ADDENDUM NO. 3

DATED: November 14, 2024

PROJECT:	WSD New Sr. High School	**DATE:**	11/14/2024
OWNER:	Wynne School District	**PROJECT NO:**	A-23010
TO:	Gary Hoyt Nabholz Construction	**CONTRACT FOR**:	General Construction

SHEET NUMBER
L1.00

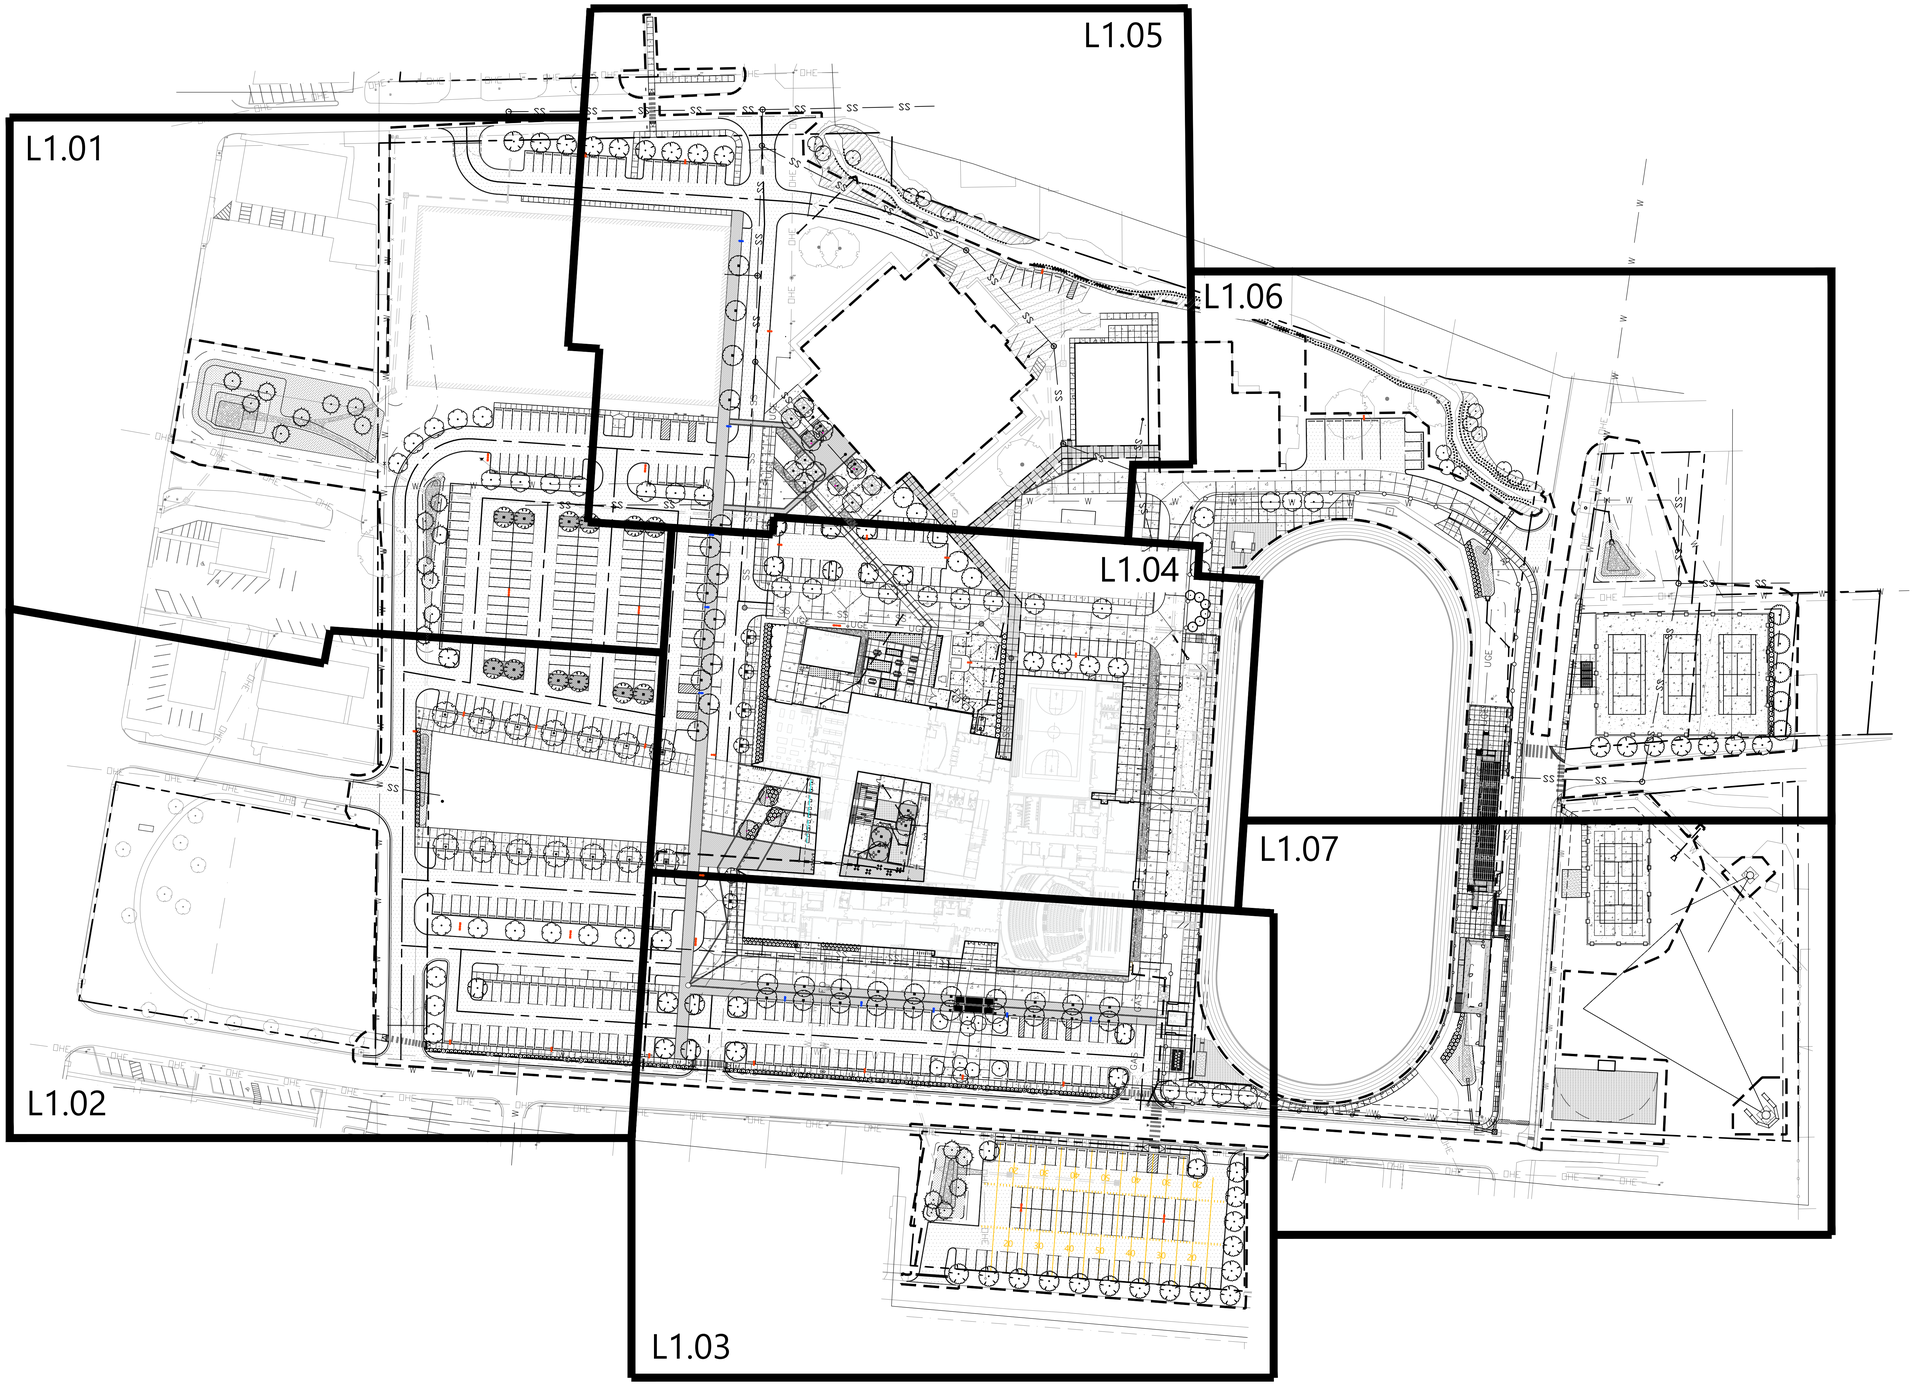
21. Sheet C5.05 SITE DETAILS: Drawing has been updated and revised as indicated on drawing sheet.
22. Sheet L1.00 OVERALL LANDSCAPE PLAN: Drawing has been updated and revised as indicated on drawing sheet.

SHEET NUMBER
L1.01

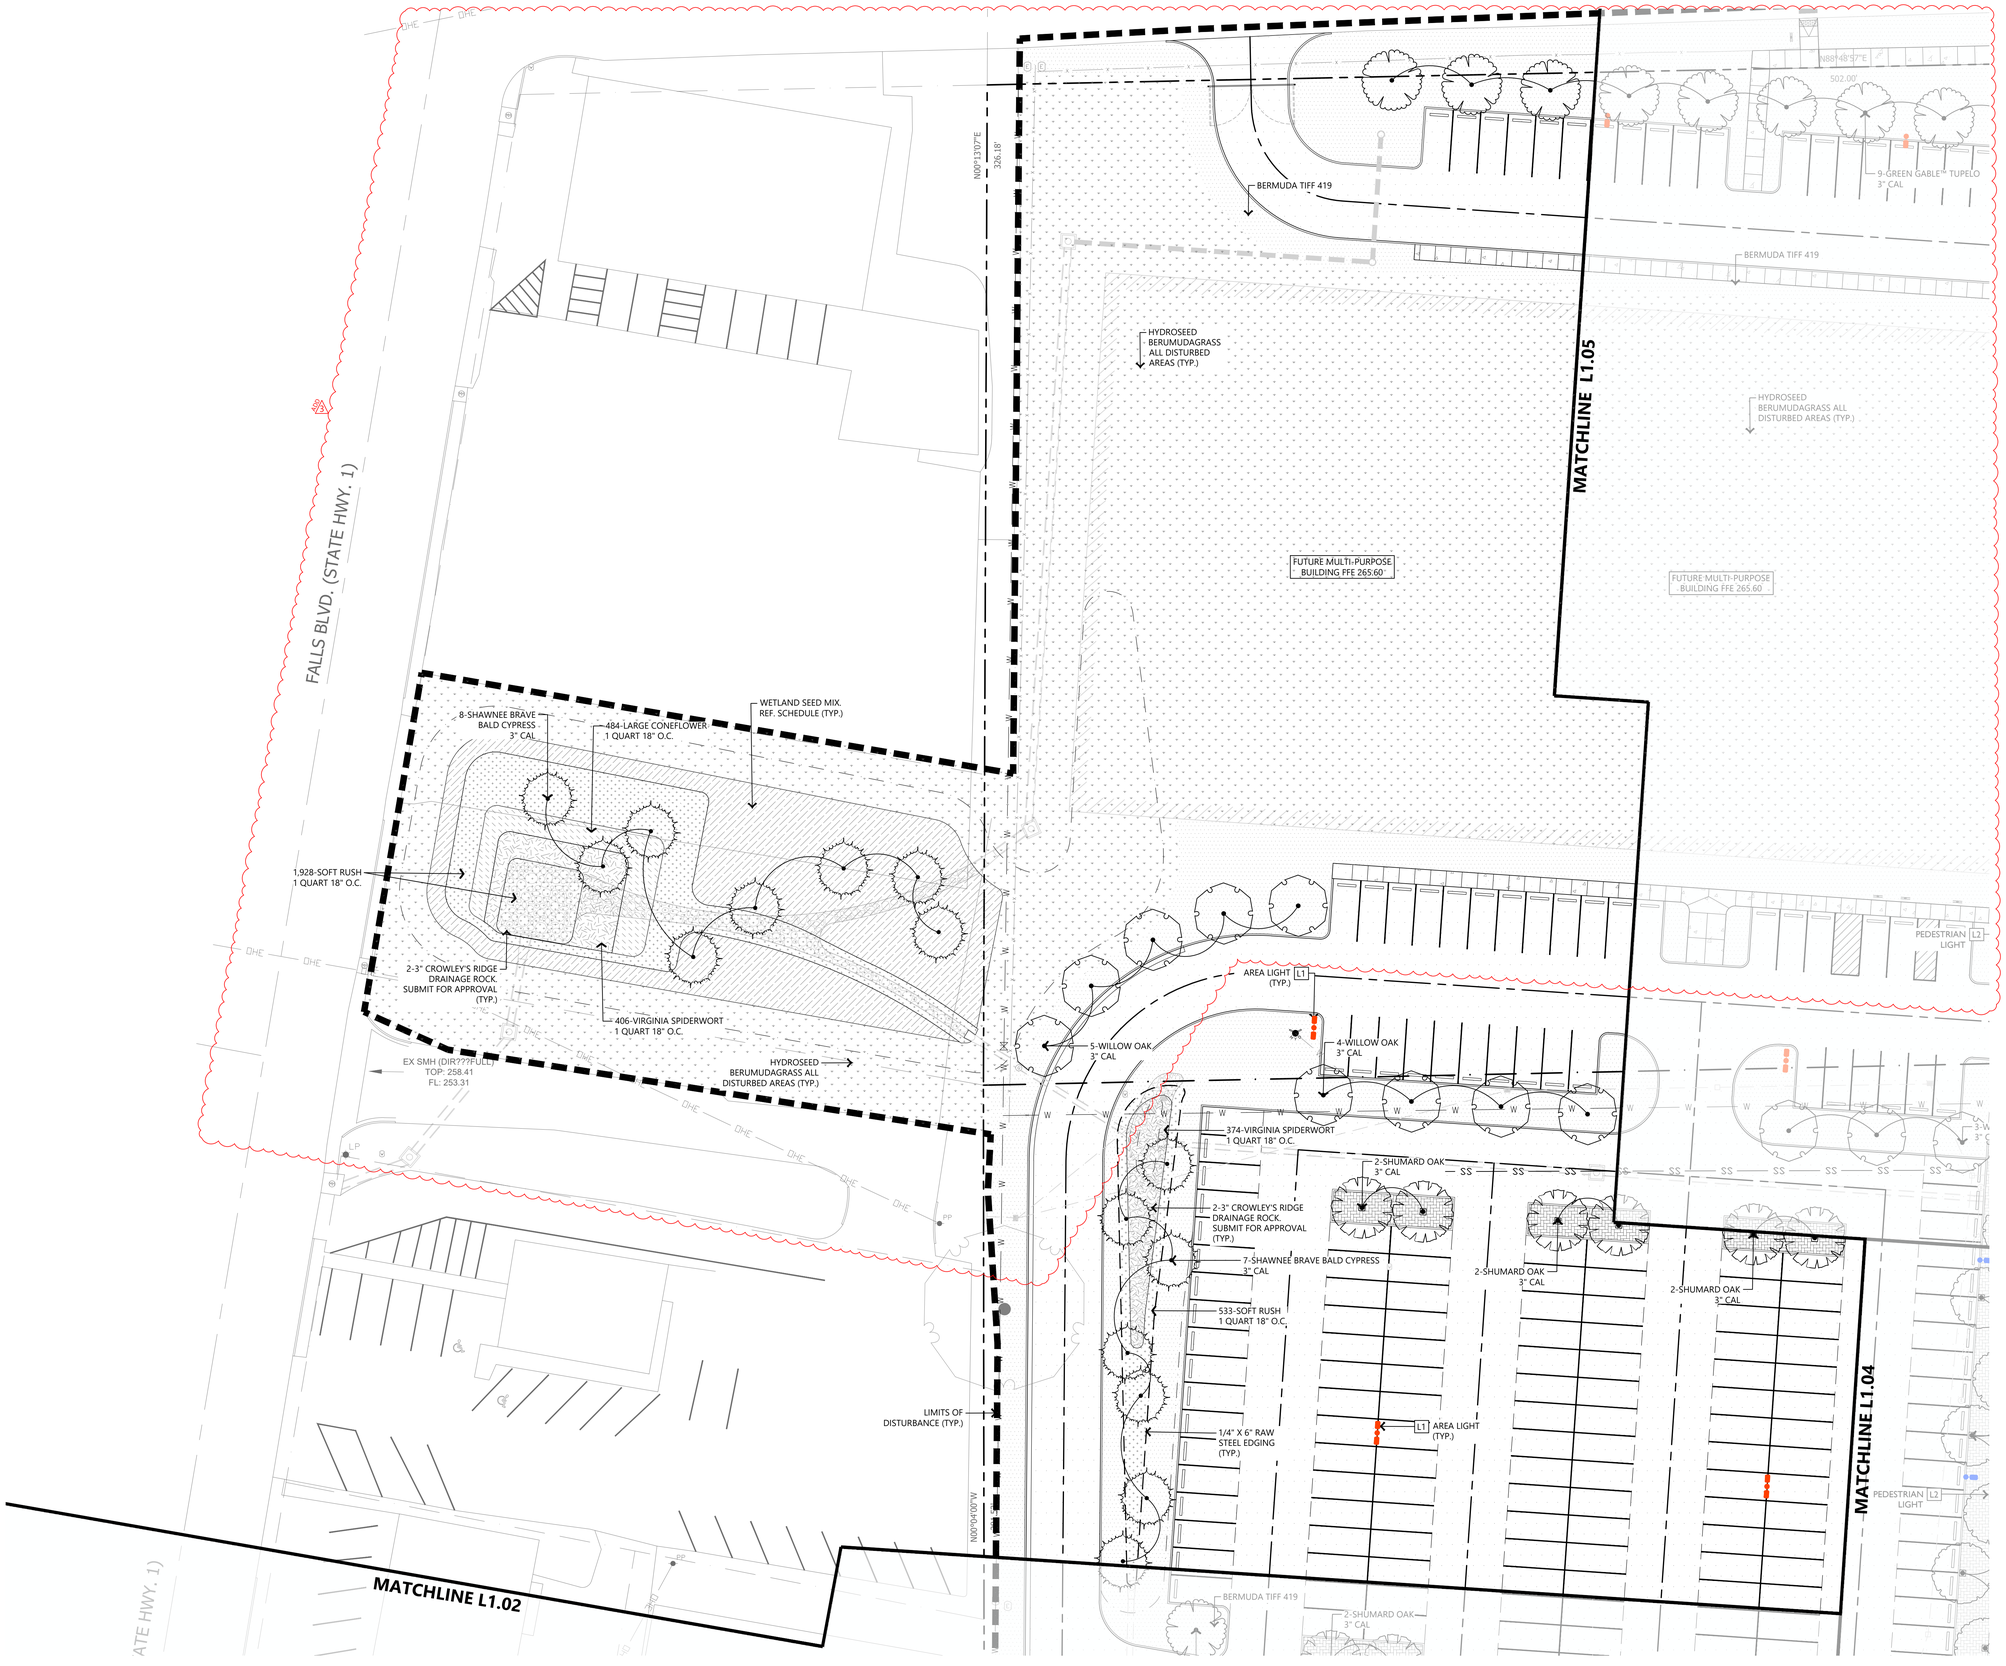
23. Sheet L1.01 LANDSCAPE PLAN: Drawing has been updated and revised as indicated on drawing sheet.
24. Sheet L1.05 LANDSCAPE PLAN: Drawing has been updated and revised as indicated on drawing sheet.

A105

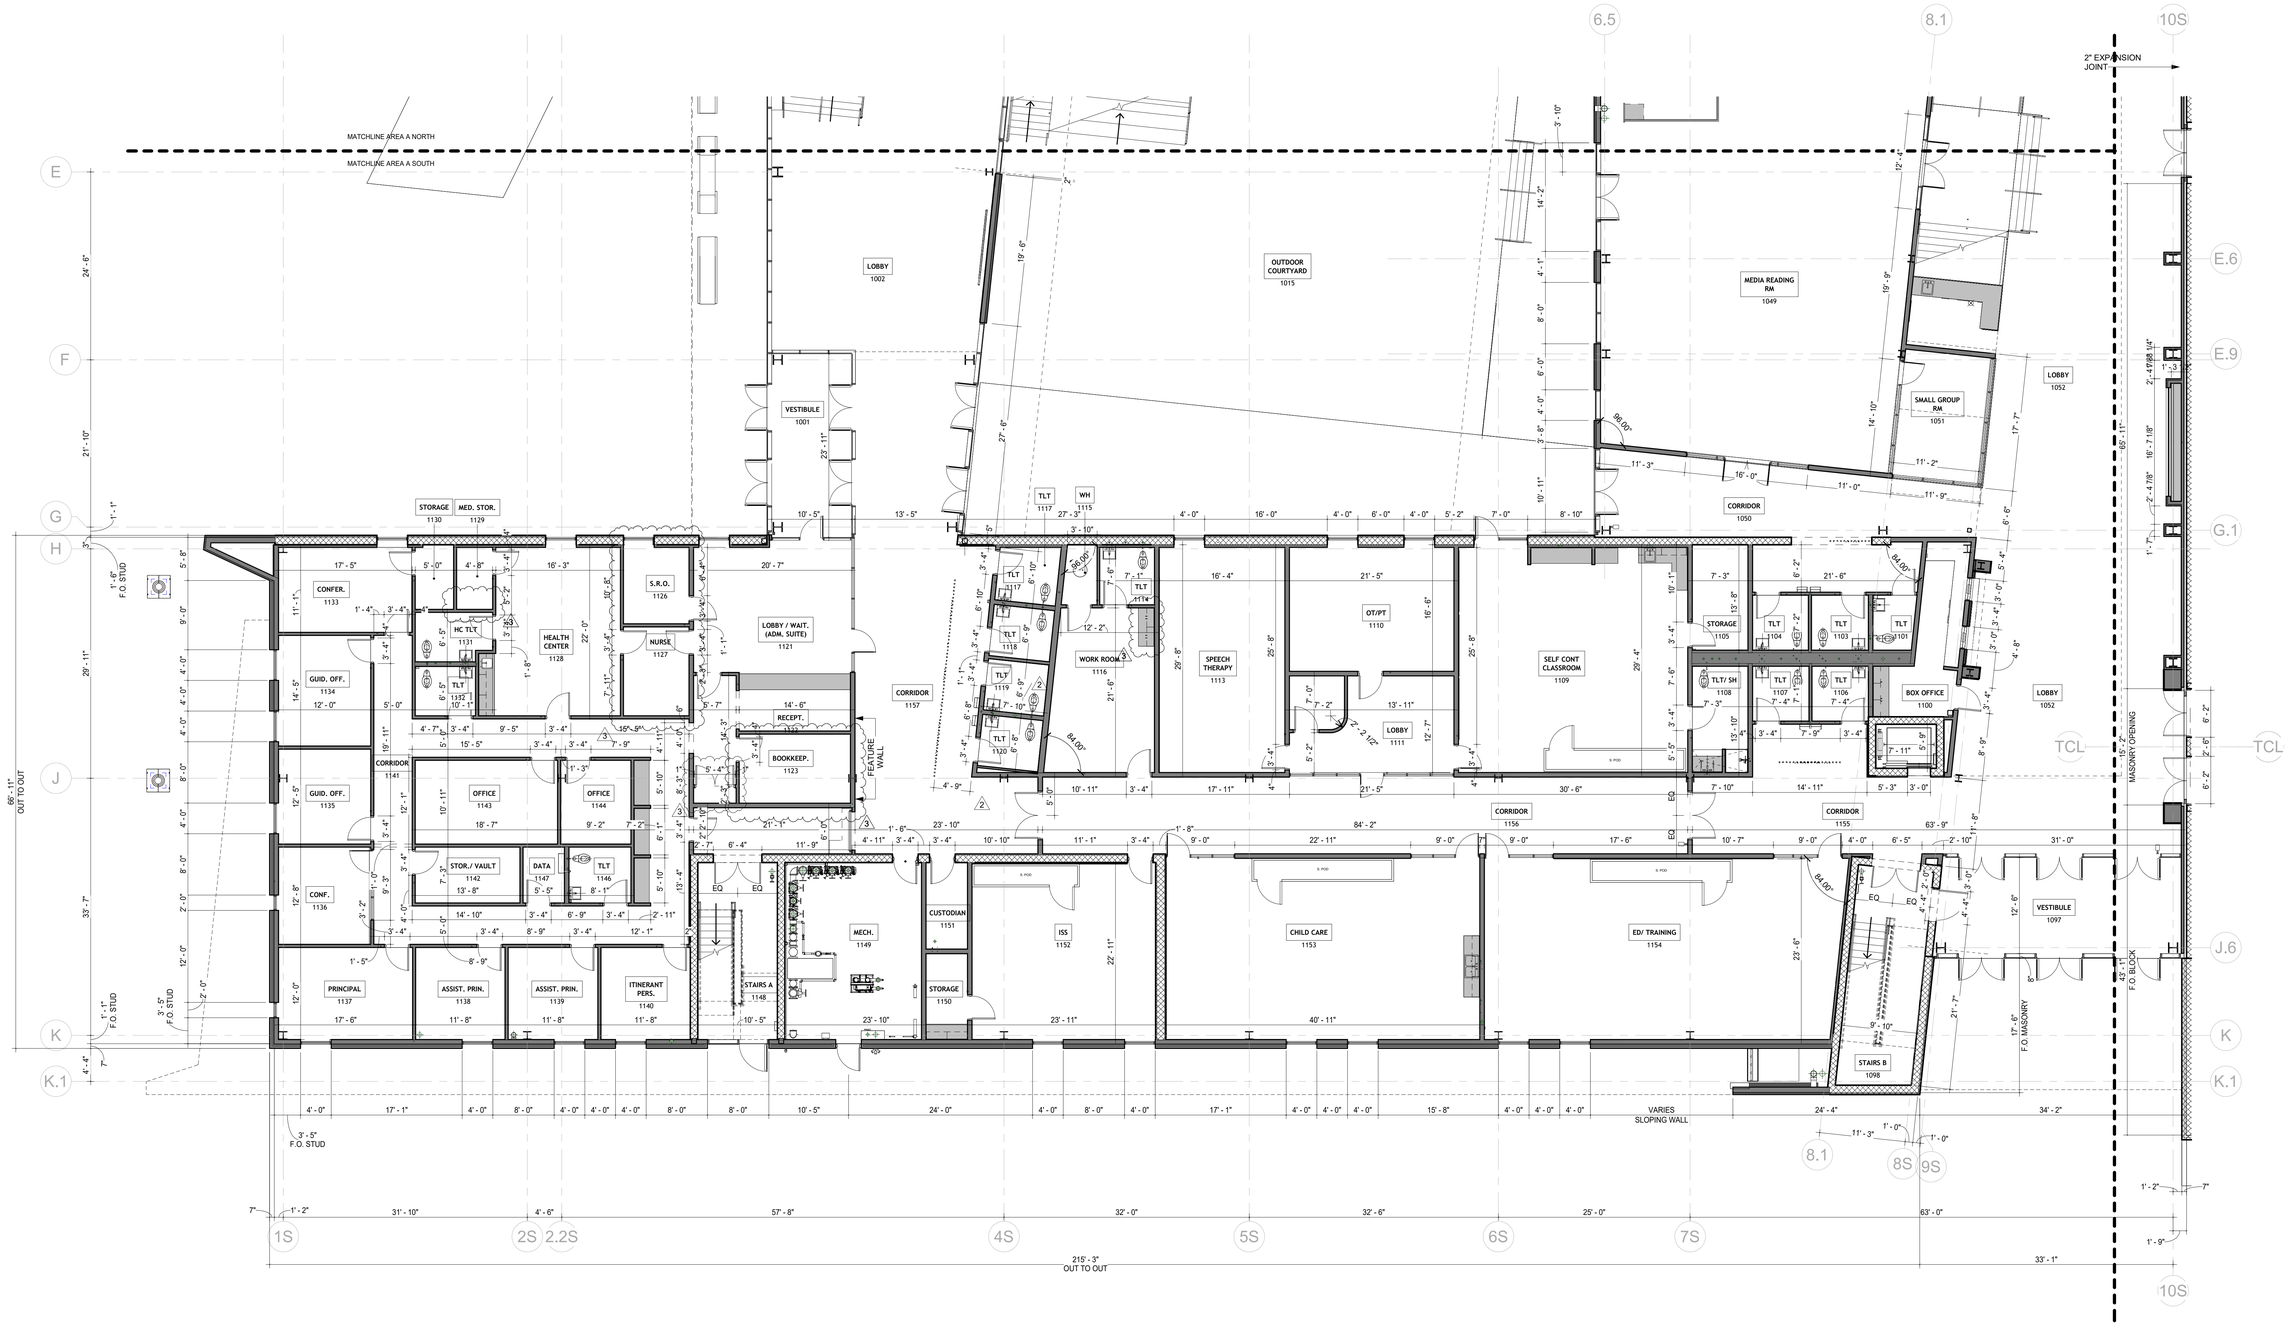
34. Sheet A104 FIRST FLOOR AREA A SOUTH -NOTE PLAN: See clouded revision ADD. 3
35. Sheet A105 FIRST FLOOR AREA A SOUTH -DIMENSION PLAN: See clouded revision ADD. 3
